## ***Interactive comment on “Uncertainties in estimating mercury emissions from coal-fired power plants in China” by Y. Wu et al.***

Response to the Reviewer #1's Comments: 1. A statement regarding the implications of the uncertainties was added according to the reviewer's comment. See lines 16-20 on page 1. 2. The year in the parentheses after the two statistical yearbooks is the publication-year of the two yearbooks instead of the data-year; indeed, the statistical data in the two yearbooks we referenced are 2003 data. There are more recent coal consumption data available now; however, the uncertainty analysis involved a lot of other data. For example, since 2003, significant amount of other types of coal (including lignite, sub-bituminous, and anthracite) has been used in power plants in China due to the increasing demand of power generation. However, we lack test data of Hg content in such coals and Hg profiles of burning such coals in China as well as

**Fig. 5.** Fig. 5. The best estimate and its uncertainty range of emissions of a) total Hg, b) Hg<sub>0</sub>, c) Hg<sub>2+</sub>, and d) Hg<sub>I</sub>, from coal-fired power plants for the whole of China and by each province in 2003.

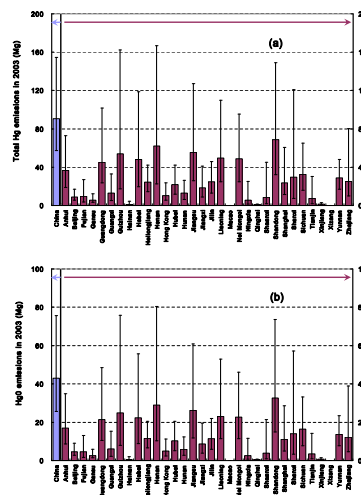
our conclusion that the major contributor to uncertainty is mercury content, followed by control technology ESP. For figures 3-4, they clearly show the uncertainty ranges and the shape of our results. Also as we discussed in the text (see page 9-10), we can find the leading contribution of Hg content in coal to uncertainties of mercury emissions by directly comparing the shapes of the curves. 5. First we should clarify that uncertainty is naturally involved in variables for our development of Hg emission inventory. Stochastic simulation is a better approach to determine the Hg emissions. Through this study, we determined the parameter, Hg content in coal, which is the leading variable affecting the uncertainty range. With our well-established database, the lognormal distribution curves were developed. The nature of such a curve inevitably results in a lower best estimate versus our previous mean point estimate and big uncertainty range, especially at the right “long-tail” side. But, we acknowledge that additional work is needed to improve the database for other variables. We added a paragraph to explain this, see lines 3-17 on page 13. 6. We cross-checked throughout the manuscript, and made several revisions of typos, grammar, and references. 7. We have redrawn Figures 1-4 according to the reviewer’s comment. And, the labels and units of the axes have been added or revised for clarity. The label in y axis for Figure 5 was revised. The five high-quality graphics were uploaded in separate files.
